## SERVICE BULLETIN

EOS engine

date of release	Sept. 2018	issue 1, #0918_1_m
for engine type / applicability	alle engines with EASY-STARTER installed	
status	<b>mandatory</b>	optional

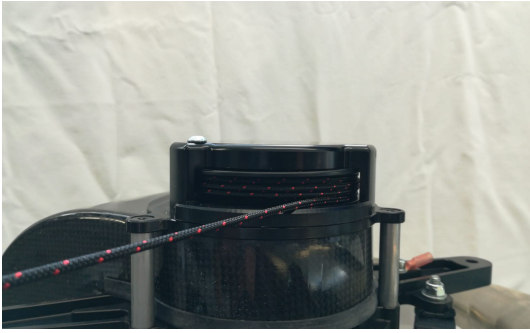
Due to recurred feed back from customers reporting that the starter rope on the EASY-STARTER when getting recoiled can guide into the gap between starter housing and rope spool and in consequence causes damage to starter rope and/or starter mechanism, magnet wheel and cooling fins, or even in worst case lead to engine shut-off, we saw need of a solution and modification.

There is no need to exchange or dismount the starter for modification but to simply add a special part - the "arc adapter" - to the starter housing by placing it on the correct location by glueing. The part comes with a glue tape added already.

Mount the arc adapter to the startr housing as per pictures shown;

clean surface with solvent

remove foil from sticky tape

place part in correct position and well press it on for permanent glueing
